1960 Corvette: Service Bulletin: Accelerator Pedal Falls Off Retaining Studs

Subject: Accelerator Pedal Falls Off Retaining Studs

Model and Year: 1960 Corvette Models

Source: General Motors of Canada - Service Bulletin

Fig. 31.

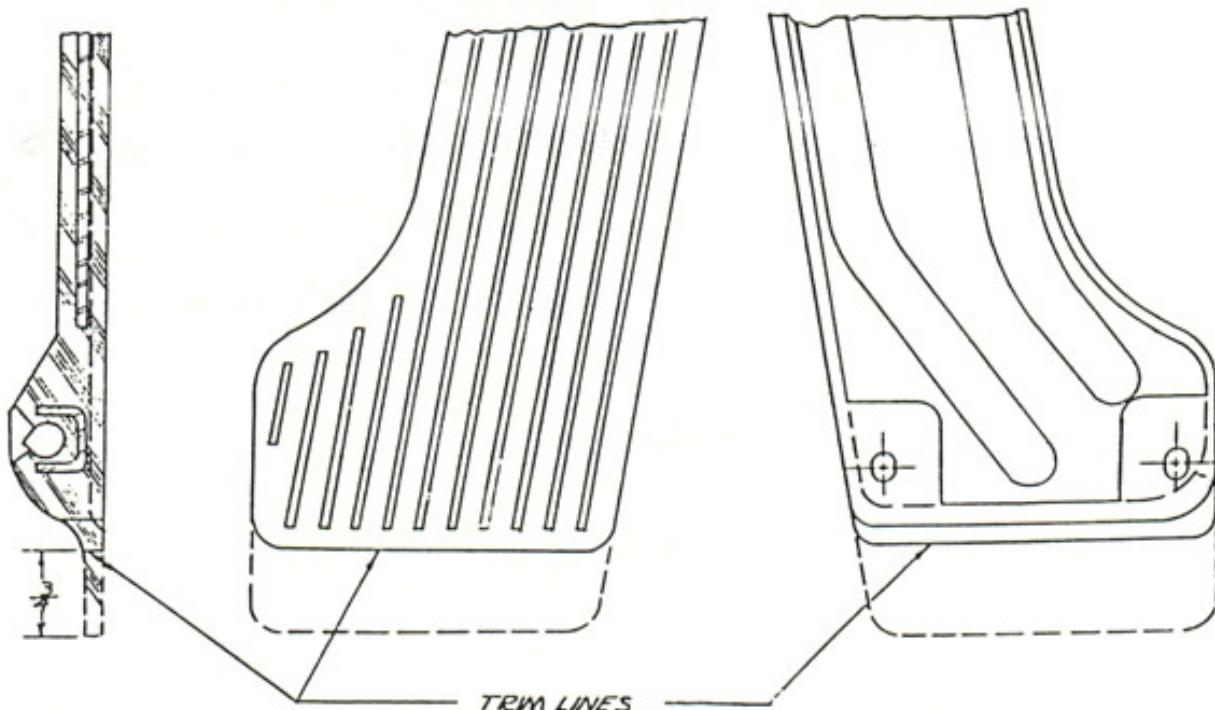
There has been a few complaints that the 1960 Corvette accelerator pedal snaps off of the two retaining studs at the heel end of the pedal, due to an interference condition between the floor mat material and the heel flap of the pedal.

REWORK INSTRUCTION DRAWING TO COVER THE MODIFICATION OF
THE 1960 CORVETTE ACCELERATOR PEDAL # 3771749

As a Production correction, the assembly plant will revert to the 1959 design pedal, part #3760271, which does not incorporate the heel flap.
